CONNECTICUT SITING COUNCIL

RE: **EM-SPRINT-007-180820** – Sprint notice of intent to modify an existing telecommunications facility located at 240 Kensington Road, Berlin, Connecticut.

Staff has reviewed this exempt modification request for completeness and has identified a deficiency in the above request for exempt modification. Construction Drawing (CD) Sheet A-2 prepared by Infinigy, last revised on July 20, 2018, includes a structural note referencing a tower Structural Analysis (SA) report prepared by B+T GRP dated May 31, 2018. However, the SA report provided with the request for exempt modification is dated June 22, 2018. The date of this SA is inconsistent with the above referenced CD notes.

PROJECT: DO MACRO UPGRADE
 SITE NAME: NEWINGTON_1
 SITE CASCADE: CT52XC109
 SITE NUMBER: 826217
 SITE ADDRESS: 240 KENSINGTON ROAD
 BERLIN, CT 06037
 SITE TYPE: MONOPOLE
 MARKET: N. ENGLAND

SHEET NUMBER:
 A-2

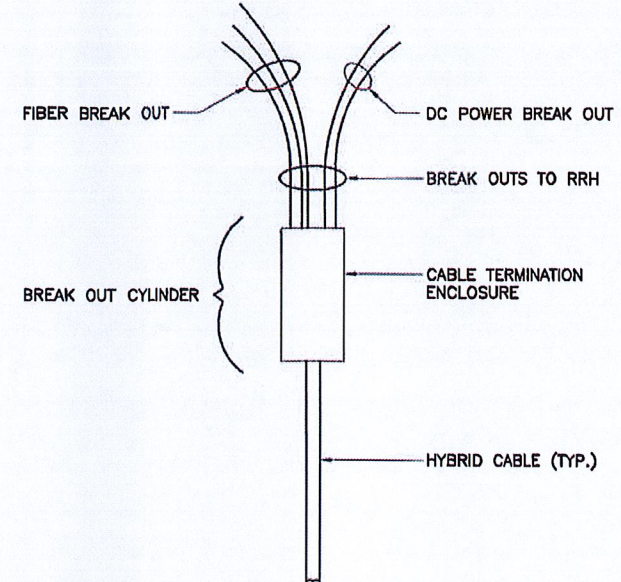
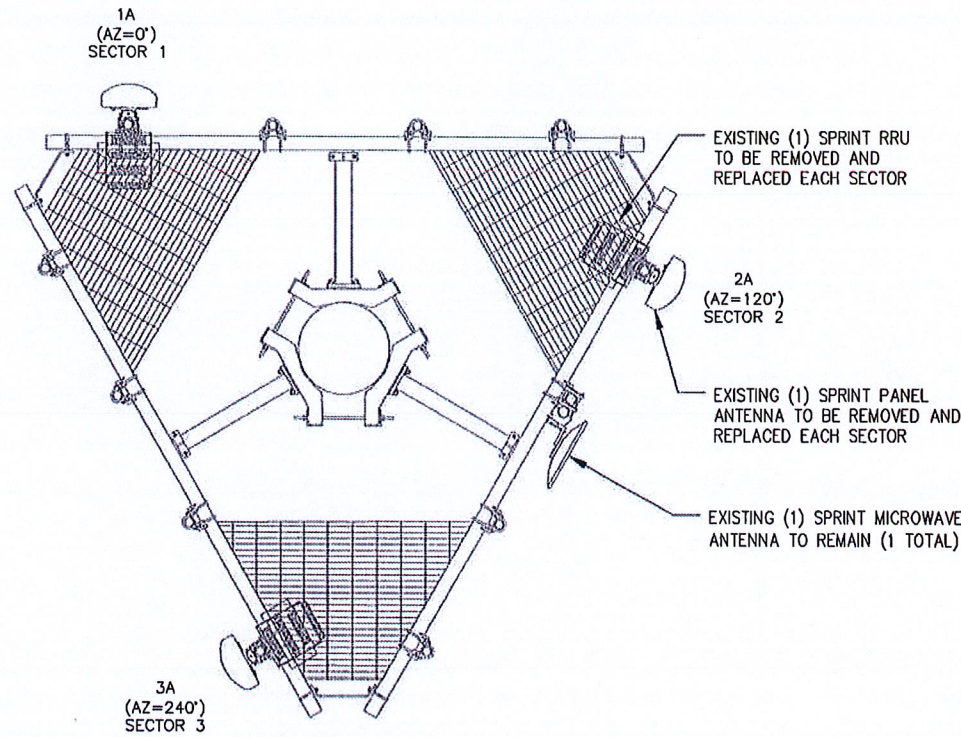
Therefore, the exempt modification request is incomplete at this time. The Council recommends that Crown Castle provide revised CDs that account for the most recent SA. This information shall be submitted on or before September 21, 2018. If additional time is needed to gather the requested information, please submit a written request for an extension of time prior to September 21, 2018.
